A Guide To Describe The Occurrence and Mitigation Of Switching Transients Induced By Transformer And Breaker-Switching Device Interaction

Figure 7 Transformer volt-time insulation characteristic used for arrester insulation coordination

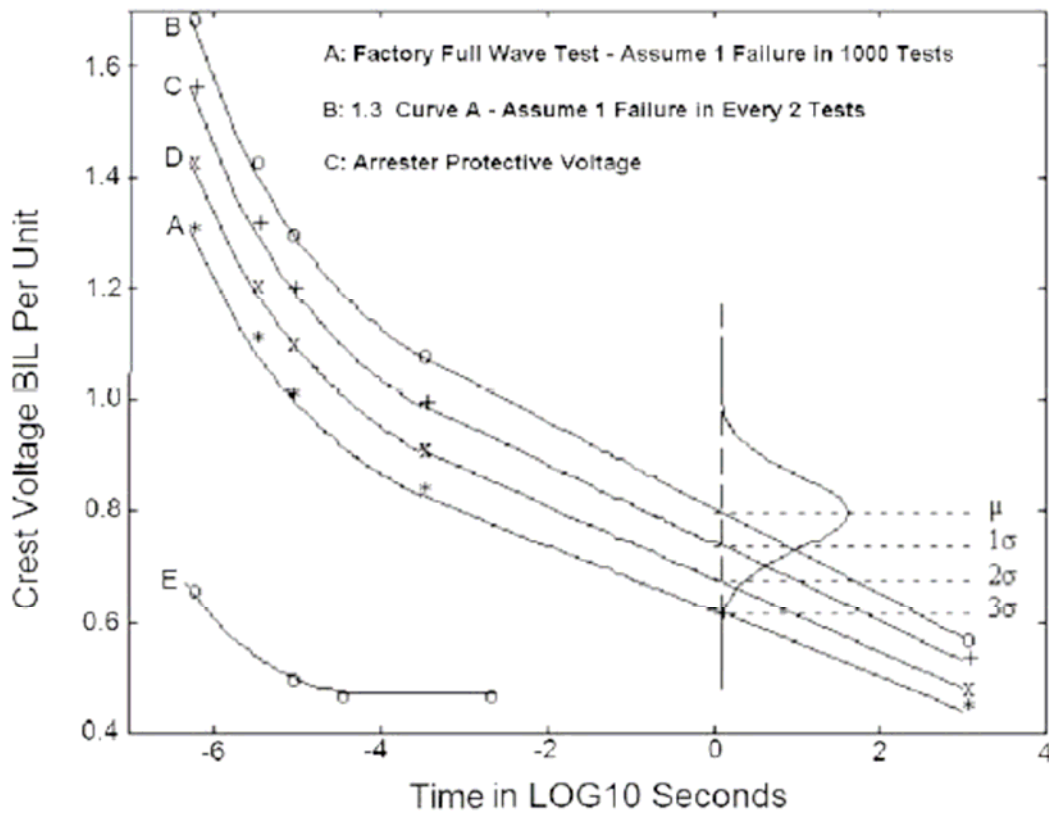
Note to Bob: Curve C is not the protective level of the surge arrester. Curve E is. May you change the legend accordingly.

Figure 8 a. Full wave and oscillatory voltage applied to H1. b. Response at center of high (point A) voltage winding.

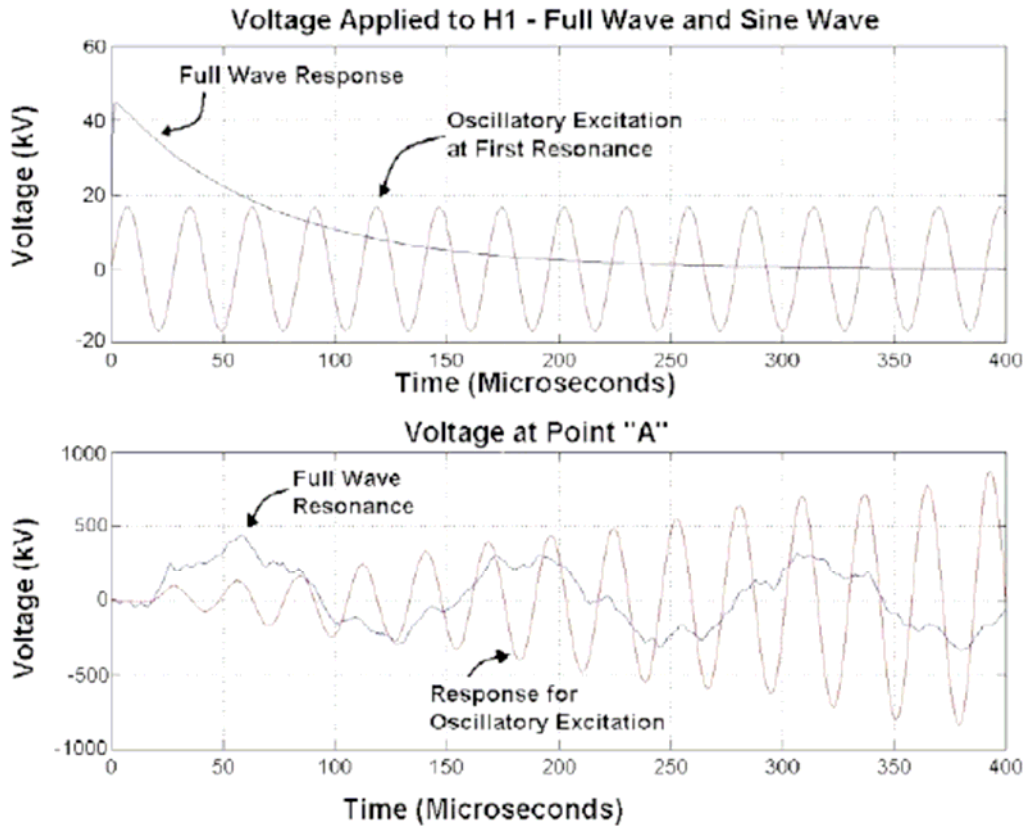
NOTE to Bob: The way that the simulation is described is not realistic of any system conditions. The TRV oscillatory mode is not a constant voltage oscillation but an exponential decaying sinusoidal excitation and normally last for less than 10 cycles (mainly where the capacitance is low and the frequency high enough). Does the simulation shown in figure 8b) consider an exponential decaying sinusoidal excitation as applied in service condition? I do not know if you can simulate an exponential decaying sinusoidal excitation but this will be more realistic of service conditions.

Figure 12 Circuit breaker with multiple re-ignitions

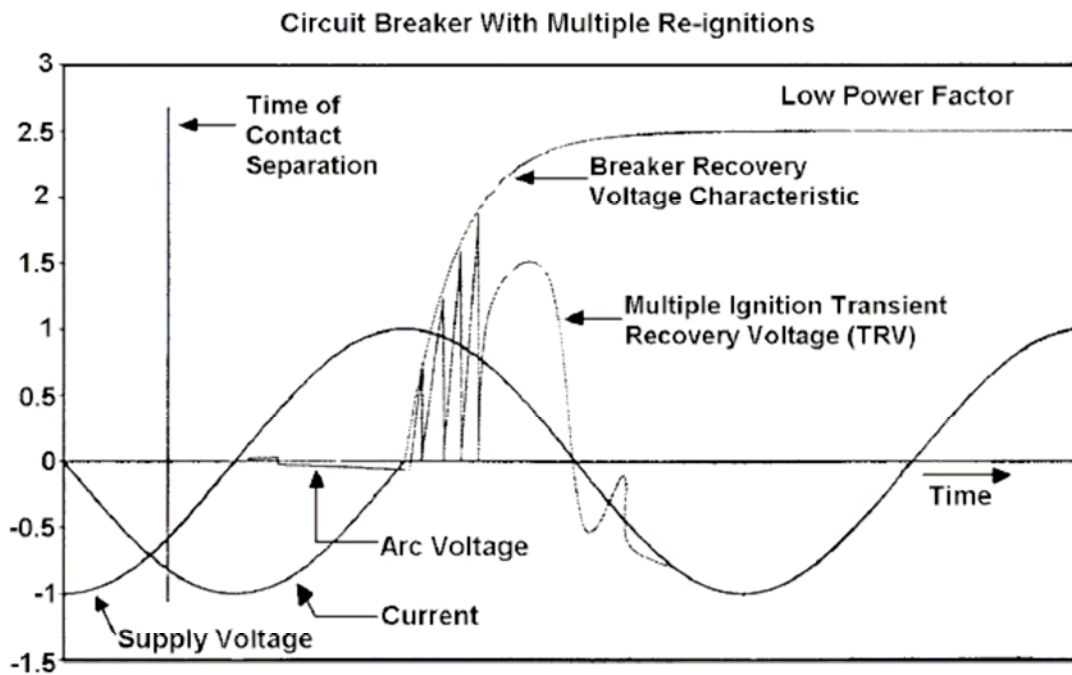
Note to Bob: The figure has to be corrected. Change "Ignition" for "Reignition"
